ADDENDUM TO FINAL REPORT

February 2005

PREFACE

Figure ADG-1: Maximum Thickness Map of Net Gas Interval; gas-water contact defined by loss of neutron-density crossover in good sands and estimated loss of gas in shaly sands based on relative changes in water saturation and quality of reservoir. Pool boundaries are ignored for contouring purposes.

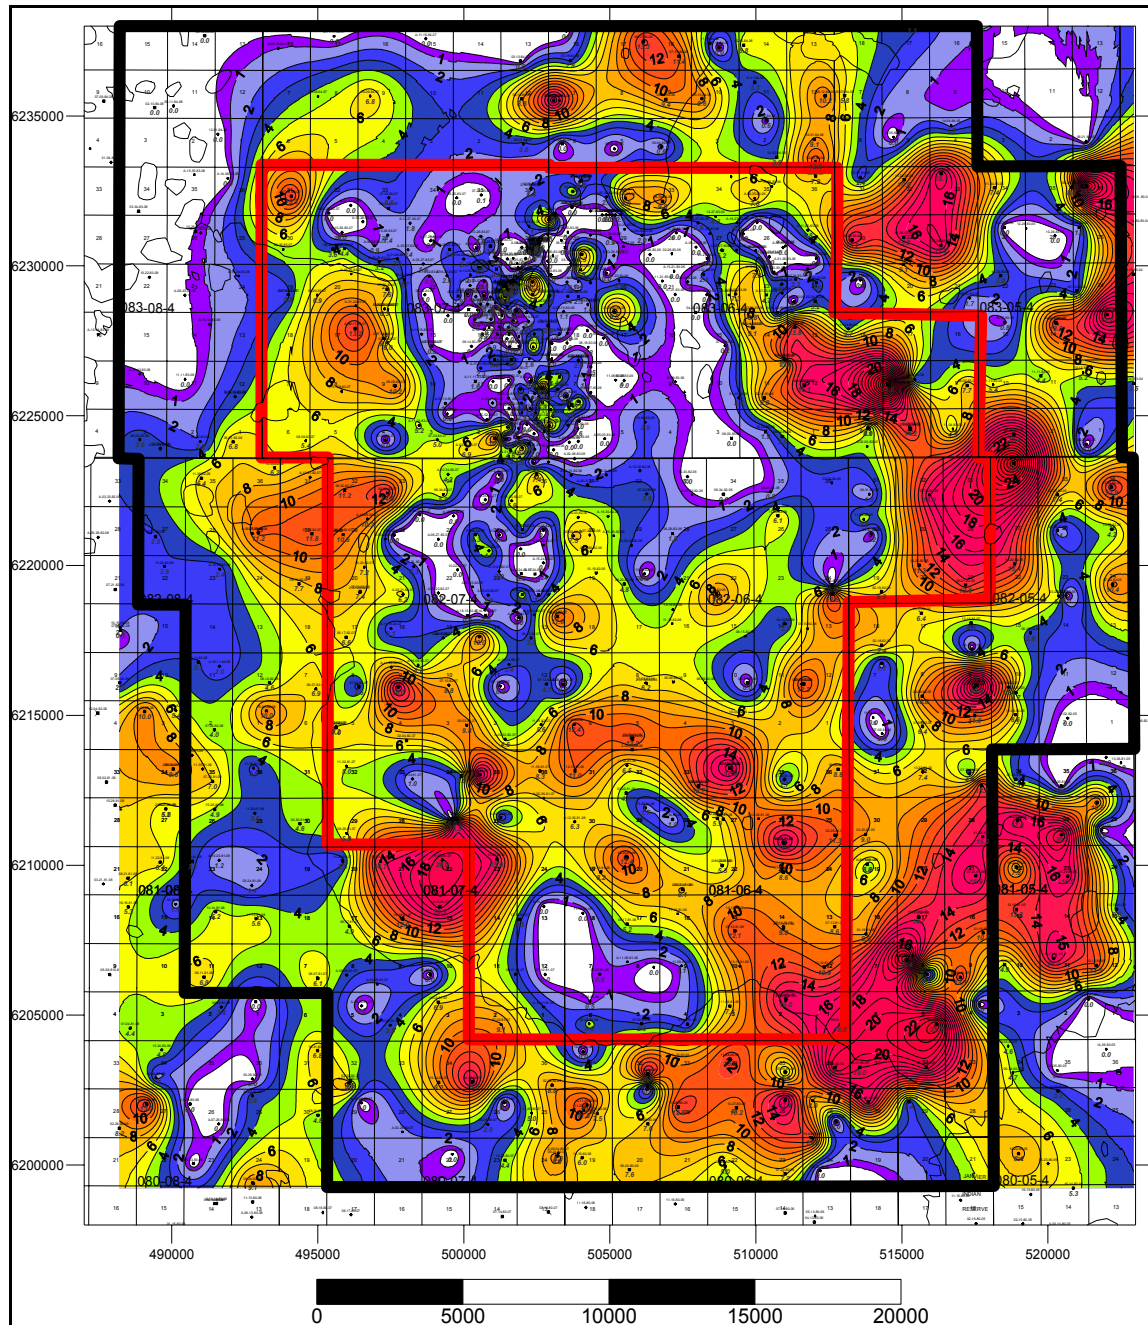
The Sub-Committee requested that Exploitation Technologies Inc. prepare additional geological maps, over and above those that were required for the tasks in the original project scope. These were to be isopach contour maps of Net Water Sand (Above Bitumen) and Net Gas pay.

1. At the Sub-Committee’s request, the net gas maps have been contoured as if there are no pool boundaries. There are in fact over 50 separate pools with distinctive yet poorly defined boundaries within the simulation area alone. Moreover, structural mapping (using additional data points and 2D seismic) indicates that nearly all production is associated with closed, very low amplitude highs; such accumulations are also strongly controlled by local stratigraphic trapping. On the other hand, closed lows between are largely barren of gas. These situations are not reflected on the continuous contoured map provided.

The new maps were prepared in SURFER, using a 25 m grid and the default Krigging algorithm. The results of mapping the newly defined intervals are presented below as **Figures ADG-1 to ADG-3**. The maximum net gas thickness map (**Fig. ADG-1**) defines the net pay interval from **G-W2** to the top of the basal Wabiskaw. The minimum net gas map (**Fig. ADG-2**) defines the net pay interval from the original **G-W** to the top of the basal Wabiskaw. The water-bearing zone map (**Fig ADG-3**) is defined as the interval of reservoir rock with 60% or greater water saturation between the top of the main Bitumen and the lowest gas contact.

Figure ADG-3: Thickness map of Water Interval with Water Saturation of 60% or higher; Blue patterned area indicates locations with no bitumen.

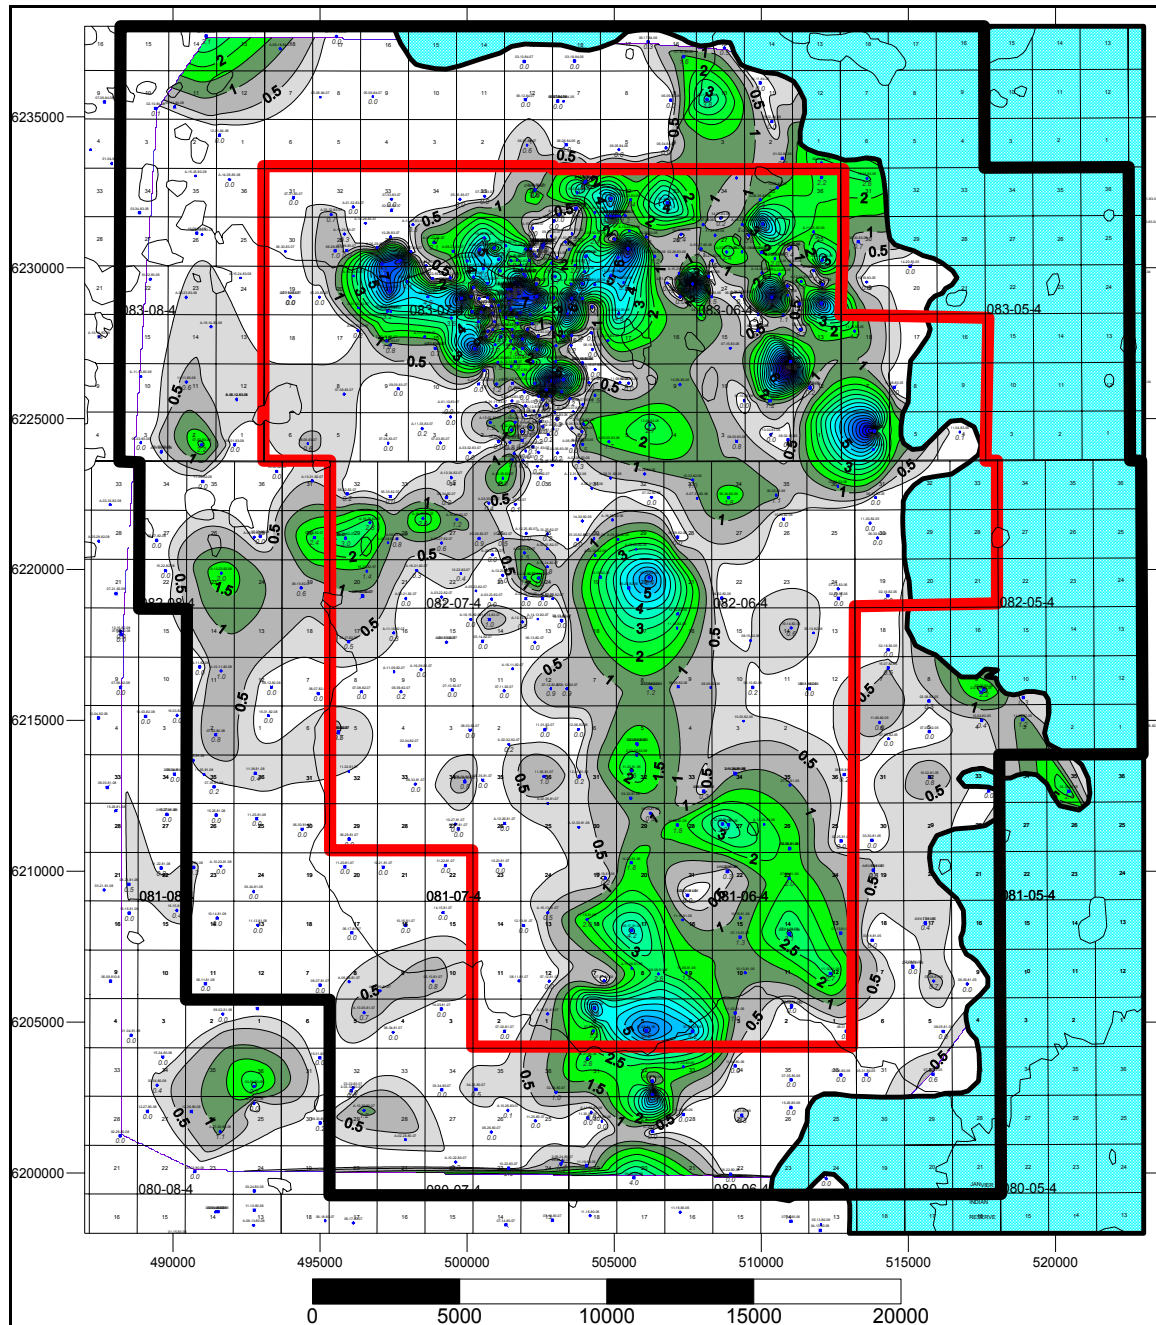
2. Because of the dramatic changes in reservoir stratigraphy between channel and non-channel facies packages and sparse drilling in many sections, the map of high water saturation likewise shows continuity that is probably far over-stated.
3. As noted above, intervals of high **Sw** do not necessarily imply significant mobile water. Areas of mobile water can only be identified and confirmed from reliable production data.

Figure ADG-4: Index Map of Pool Cross Sections; Heavy Red Line = Boundary of Simulation Area; Heavy Blue Line = Boundary of Buffer Area; Blue Boxes = Pool Boundaries from Reservoir Simulation Results.

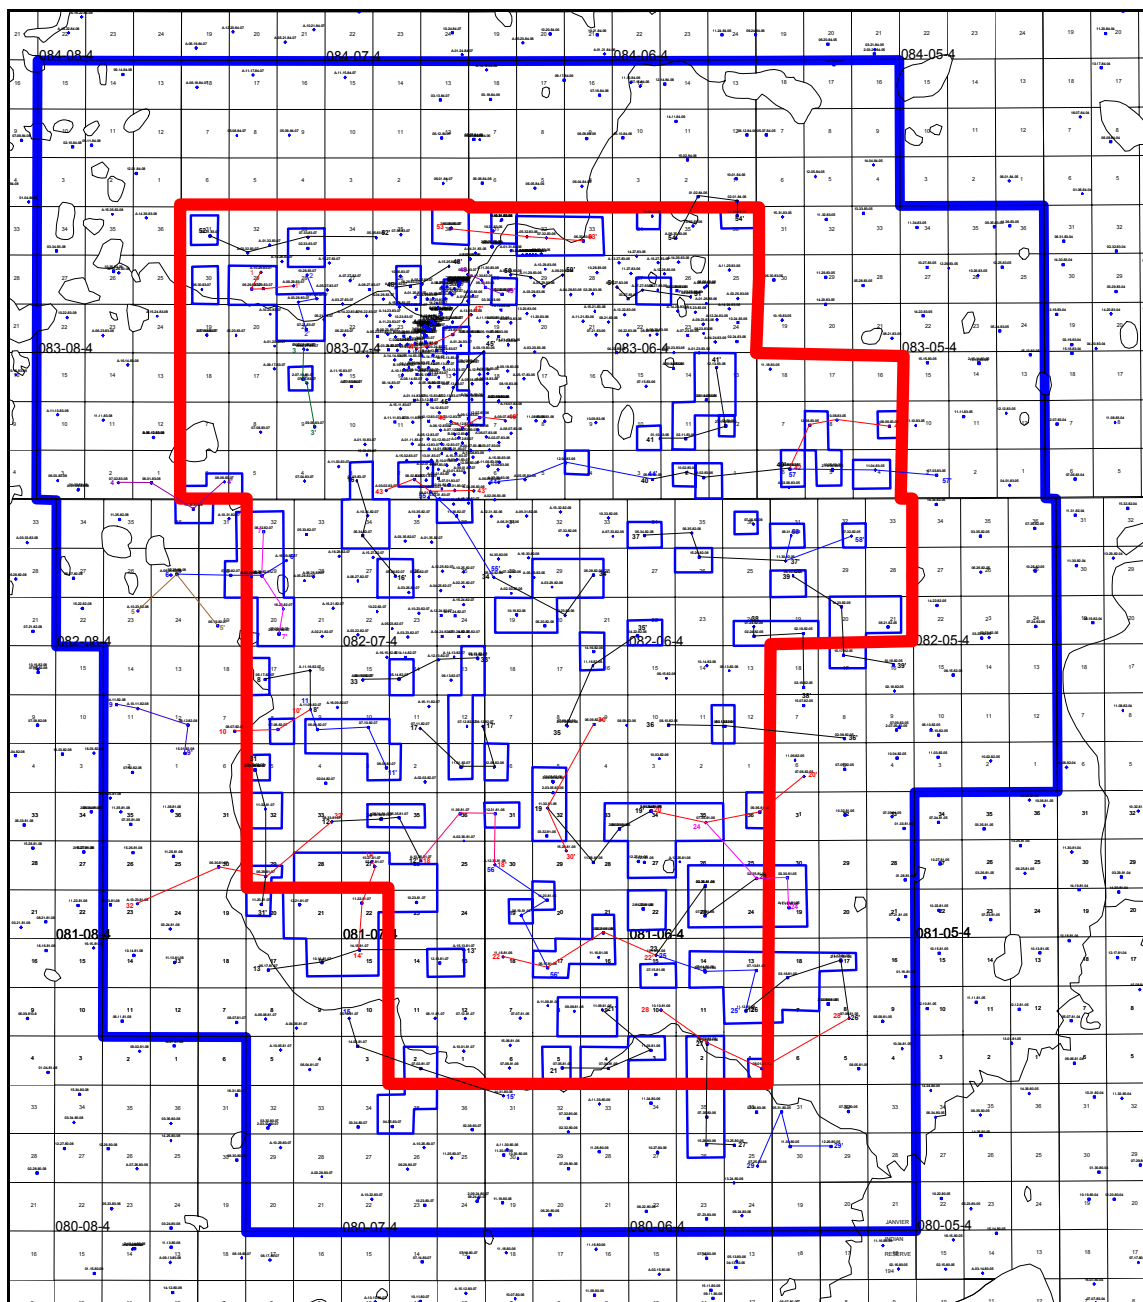
The Sub-Committee requested index maps for the cross-sections that were included in the original report. These have been addressed as follows:

Figure ADG-4 is a complete index map of all of the Pool cross sections presented in the original report with pool boundaries included (original Figs.G-36 to G-92, inclusive).

Figure ADRS-1

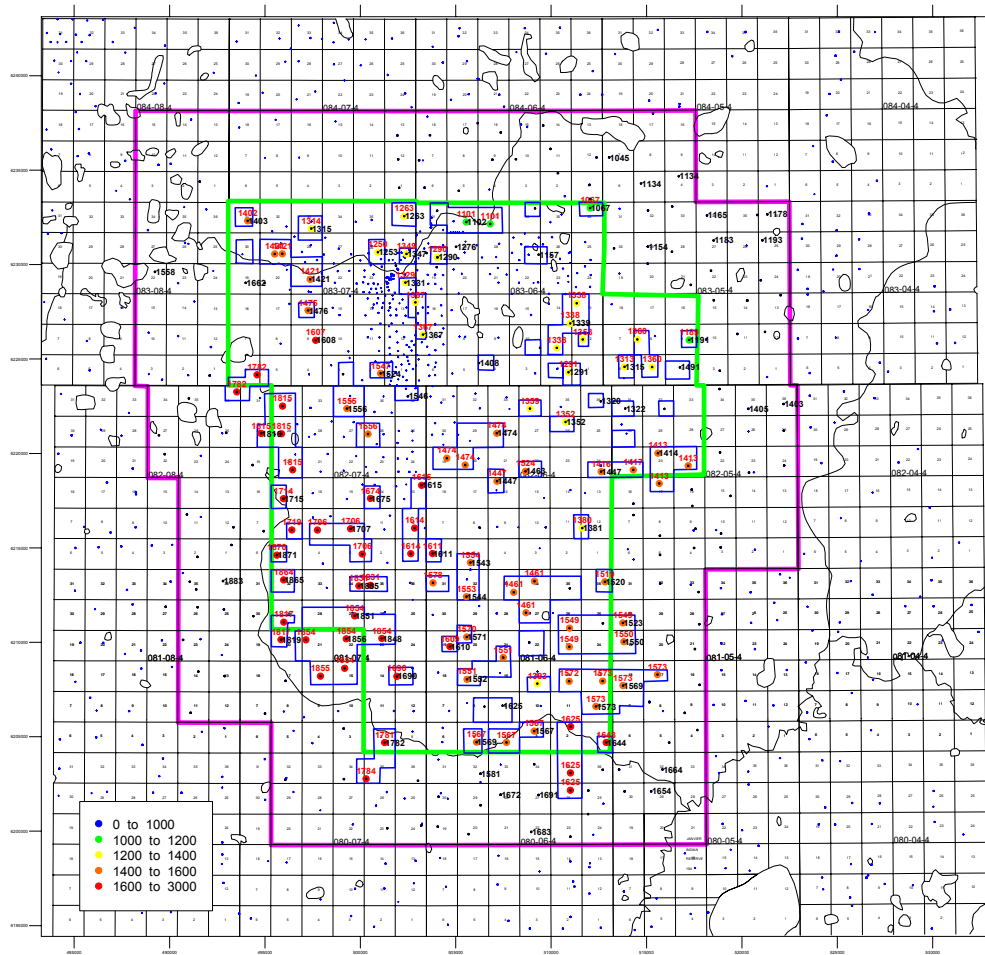
ETI was requested to provide six maps of the field pressure distribution at specific times. Simulator data was to be displayed as a class map, with colour coded symbols for various pressure ranges, while field data was to be contoured, ignoring pool boundaries. The data and the time periods used are detailed below:

- Initial pressure of wells was to be contoured. This was modified to initial pool pressures from simulator data only, since some pools had infill wells drilled after discovery and the measured pressures from the later infill wells would cause contouring anomalies, if production had already taken place. The data for this map was to be presented as a classed post map with colour ranges for pressure groups as **Figure ADRS-1**. Also presented on the map are posted values of valid field initial pressures for each pool.
